Dealer Service Instructions for:

Safety Recall R32 / NHTSA 15V-431 Engine Beauty Cover

2011-2015 (JC) Dodge Journey

2011-2015 (JF) Fiat Freemont

Figure 2 – Grommet Structure

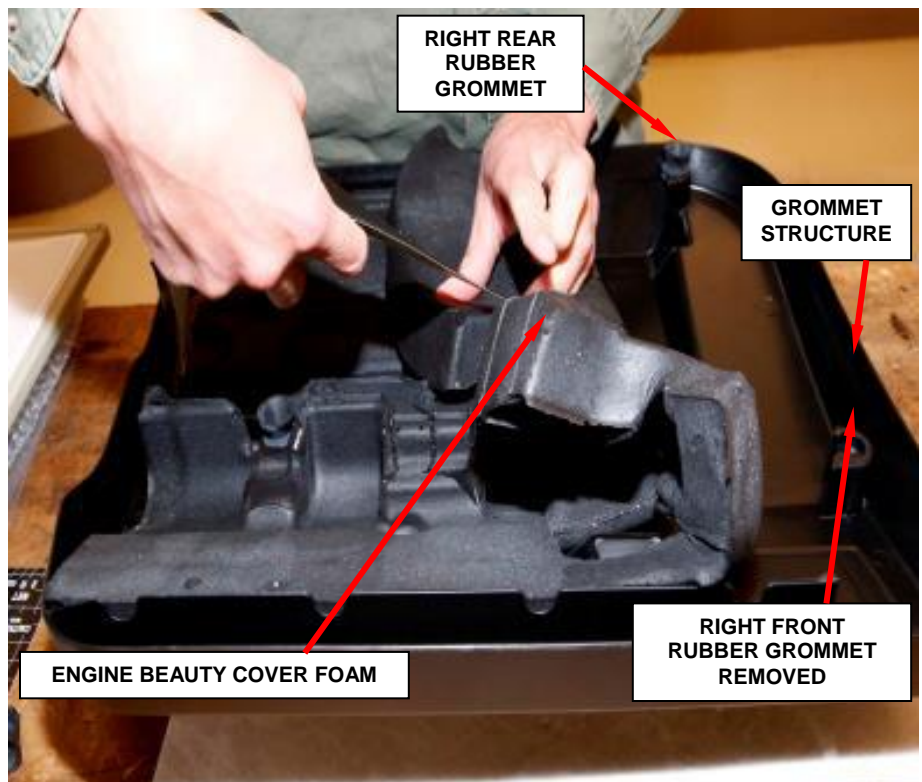
1. Open the hood.
2. Grasp the engine beauty cover and pull upward (Figure 1).
3. Remove the engine beauty cover (Figure 1).
4. Place the engine beauty cover on the topside then remove and discard the existing right front rubber grommet from the grommet structure (Figure 2).

5. Pull back the engine beauty cover foam to access the right front grommet structure (Figure 2).

NOTE: To assist steps 6 through 11, tape the foam out of the way (Figure 2).

Figure 3 – Right Front Grommet Structure

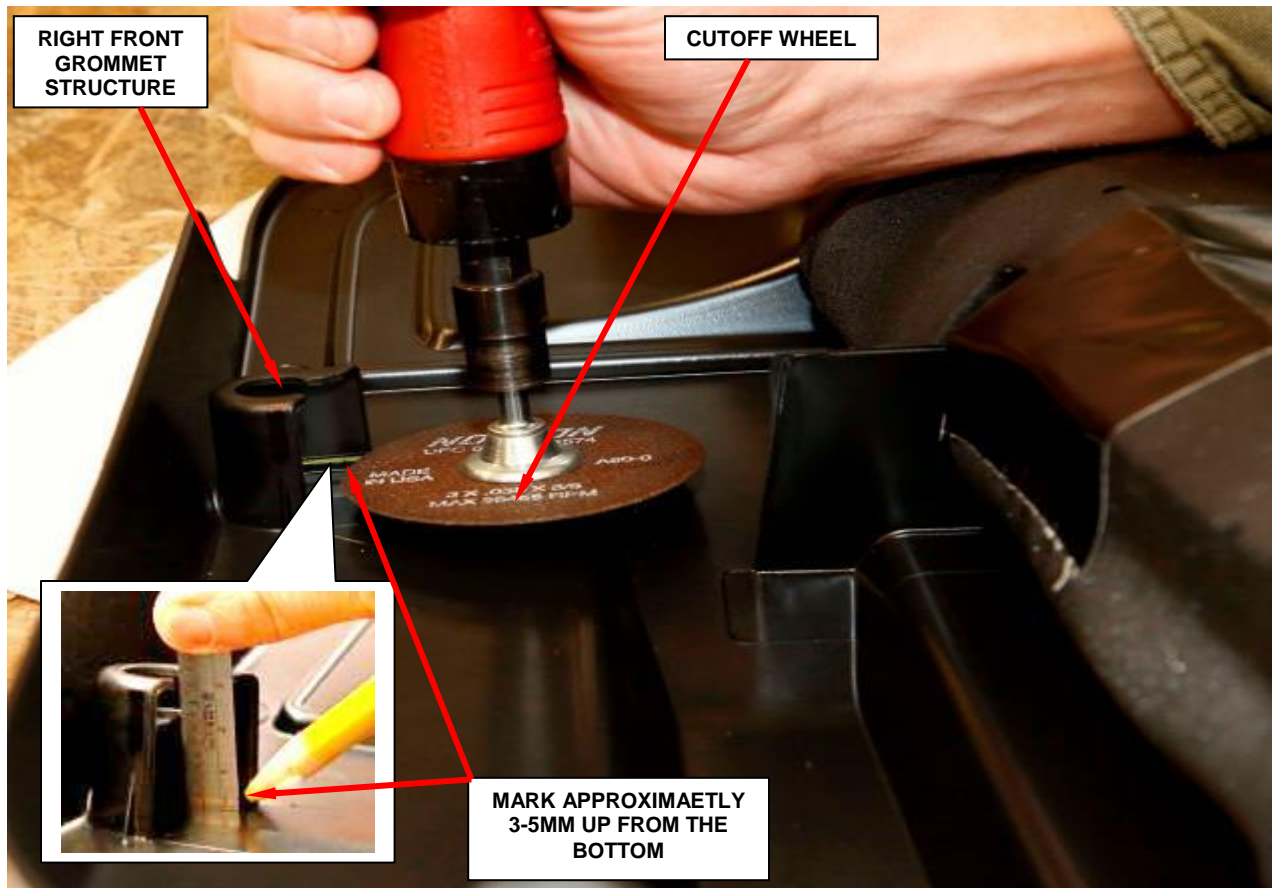
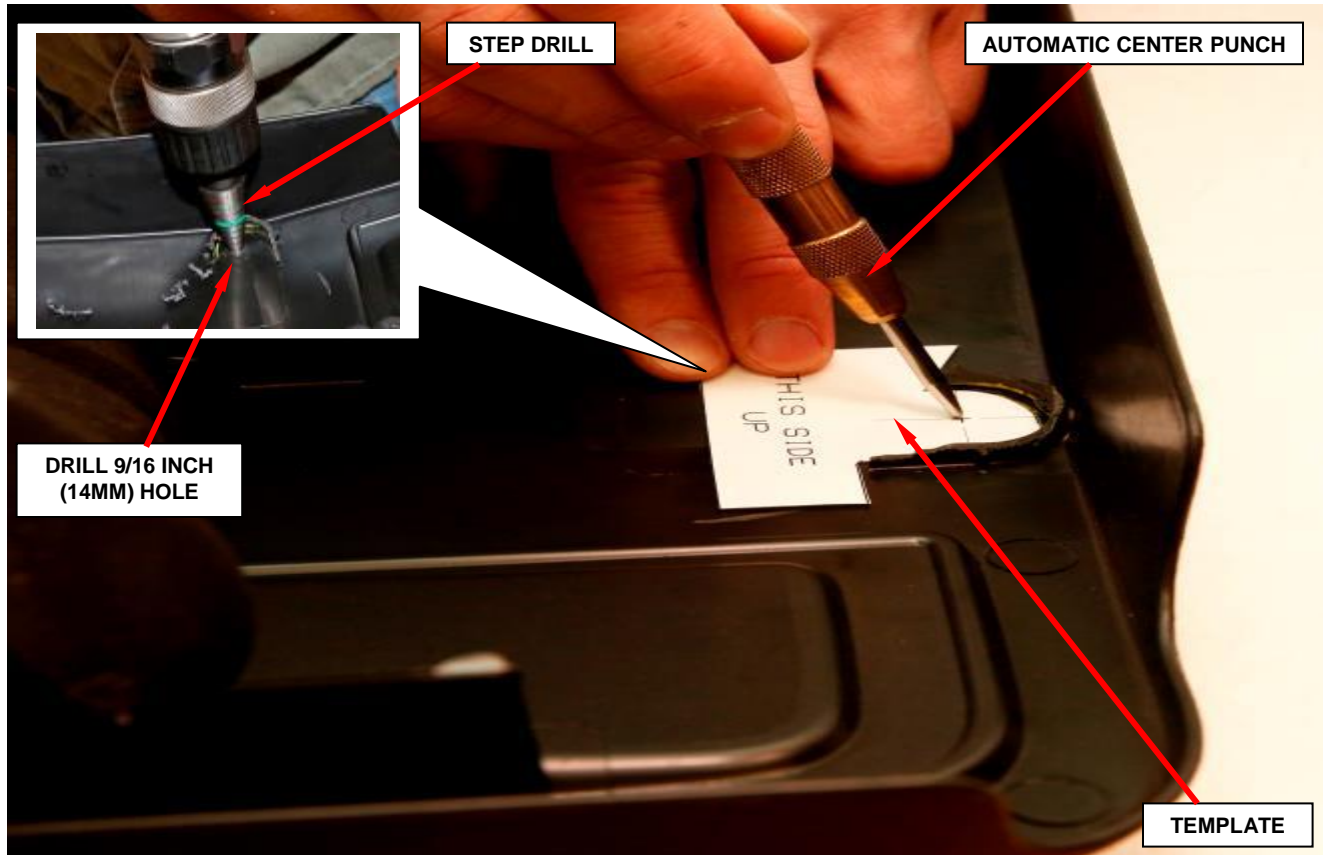
6. Using a china marker, mark the right front grommet structure approximately 3-5mm up from the bottom of the engine beauty cover (Figure 3).
7. Using a cutoff wheel or equivalent, remove the right front grommet structure. Use the china mark as a guide (Figure 3).

Figure 5 - Rubber Isolator

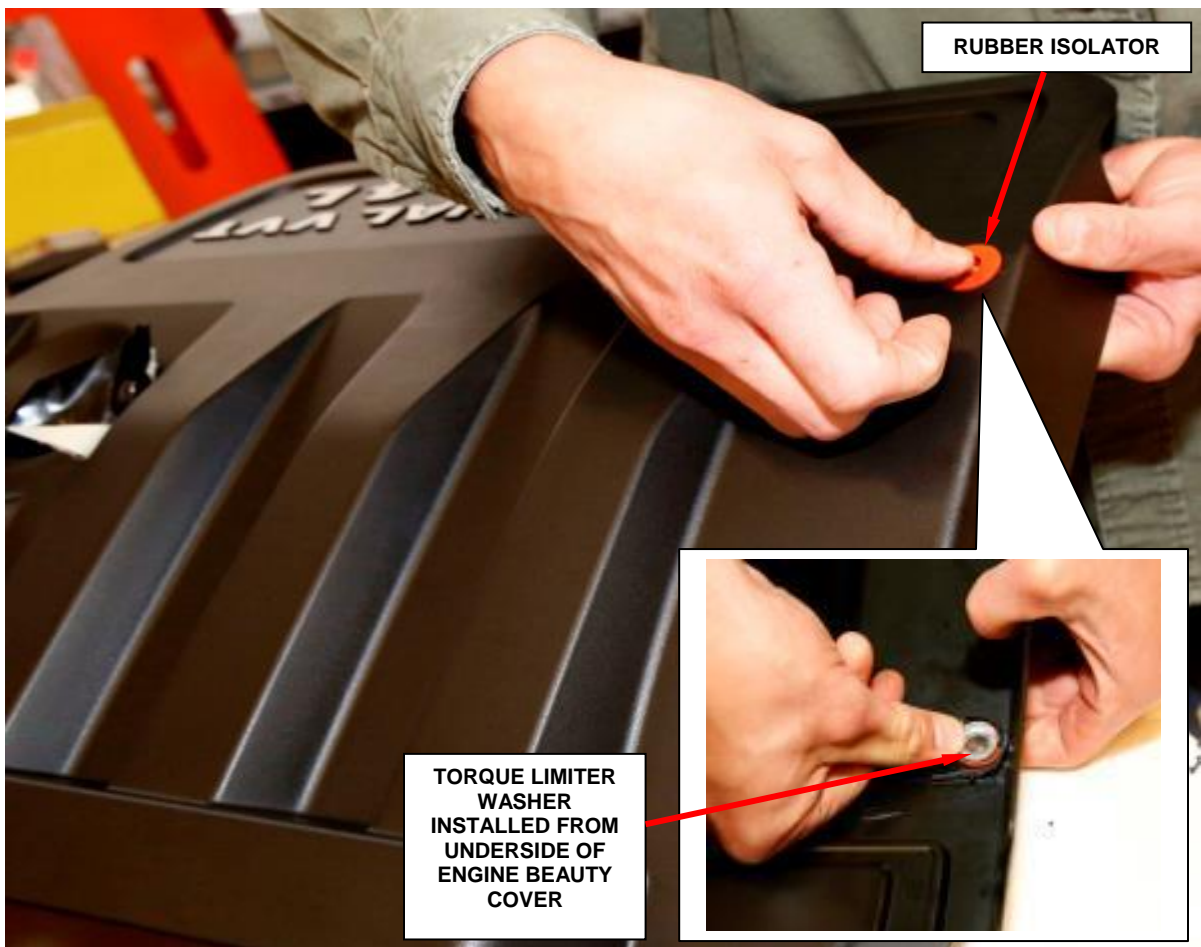
12. Remove and discard the tape from the foam and position the foam to the engine beauty cover.
13. Install the rubber isolator provided with the kit into the newly drilled 9/16 inch (14 mm) hole in the engine beauty cover (Figure 5).
14. Install the torque limiter washer provided with the kit into the rubber isolator from the underside of the engine cover (Figure 5).

CAUTION: Be sure the torque limiter washer is installed from the underside of the engine beauty cover with the large side of the washer facing down as shown in Figure 5.

Figure 6 – Right Front Ball Stud

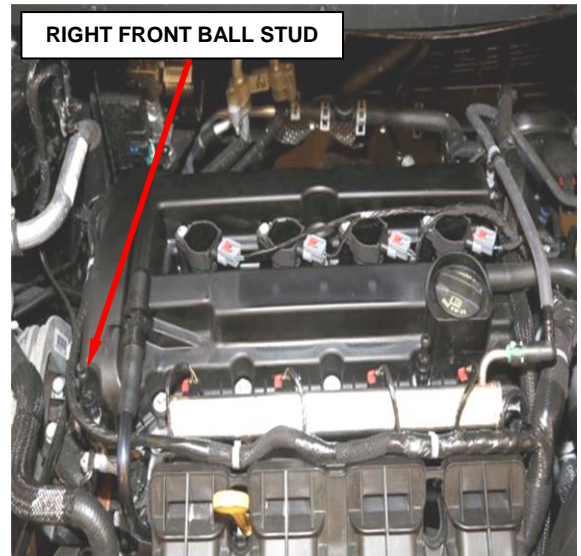
15. Remove and discard the right front ball stud (Figure 6).
16. In the same location where the right front ball stud was removed, install the new standoff provided in the kit to the stud using Loctite® 243 and tighten to 62 in. lbs. (7 N·m) (Figure 7).

Figure 7 – Stand off

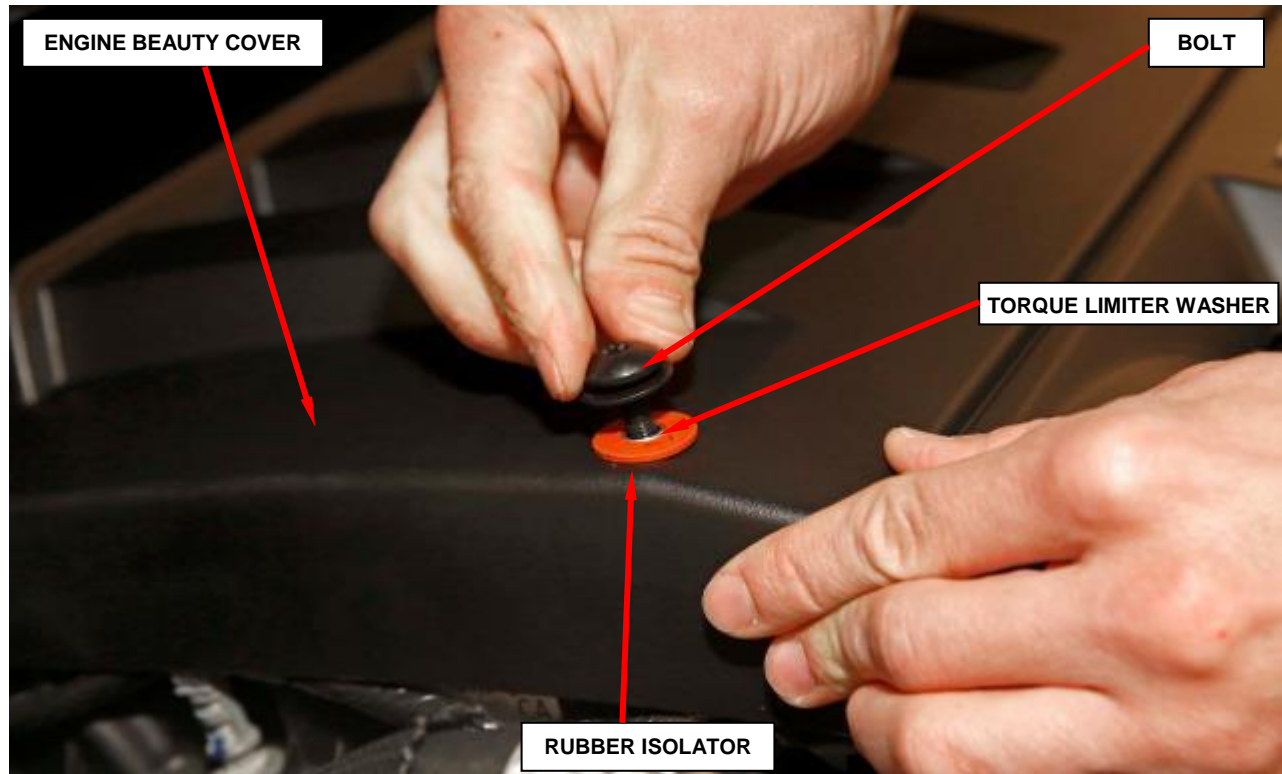
CAUTION: The standoff must be installed by hand and tighten using a hand tool. Avoid using an air tool.
